SUBJECT: TECHNICAL ASSISTANCE REQUEST - UNIVERSITY OF MICHIGAN

SUBJECT: Forwards proposed revs to emergency plan, reflecting reorganization of facility mgt. Reactor operators are not required to be in line of succession for emergency director.

The University of Michigan requests that the Ford Nuclear Reactor Emergency Plan be modified as follows:

Figure 7 Ford Nuclear Reactor Emergency Organization

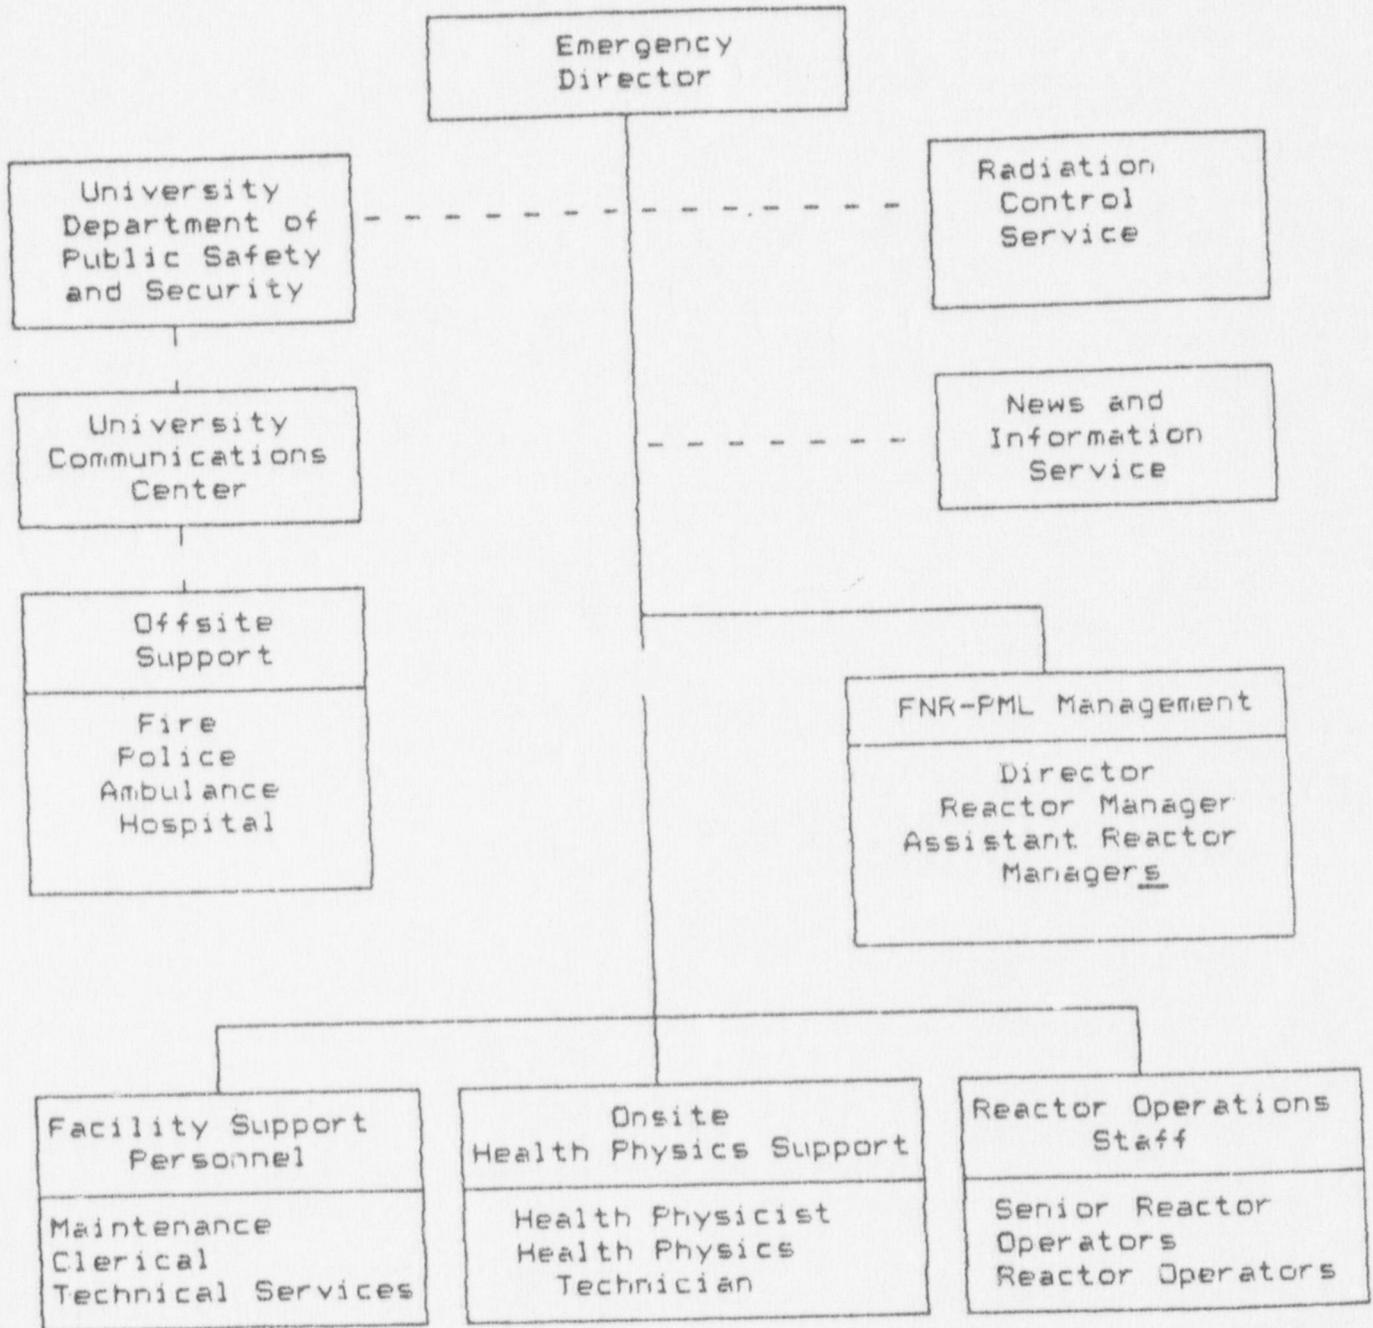
Page	Section	Description
13	Fig 7	In FNR-PML Management, change Assistant Reactor Manager to Assistant Reactor Managers
14	3.1.1	Eliminate lead reactor operator and reactor operator from the Emergency Director line of succession. Add a second Assistant Reactor Manager.
14	3.1.3	Eliminate the assumption of Emergency Director responsibilities by the lead reactor operator on shift.
15	3.1.4	Add a second Assistant Reactor Manager to the facility management.
App 3-5 to 3-12		Added K. Conway to and deleted C. Brannon from emergency staff.
App 3-13 to 3-14		Changes to building names, supervisors, and telephone numbers.
App 4-9		Changes to facility staff.
App 4-10		Changes to Ann Arbor emergency personnel.

The changes to pages 13 to 15 have been made because facility management has recently been slightly reorganized. A second Assistant Reactor Manager has been added. The Reactor Manager and both Assistant Reactor Managers are licensed Senior Reactor operators. One of the three is always on duty as facility on-call supervisor.
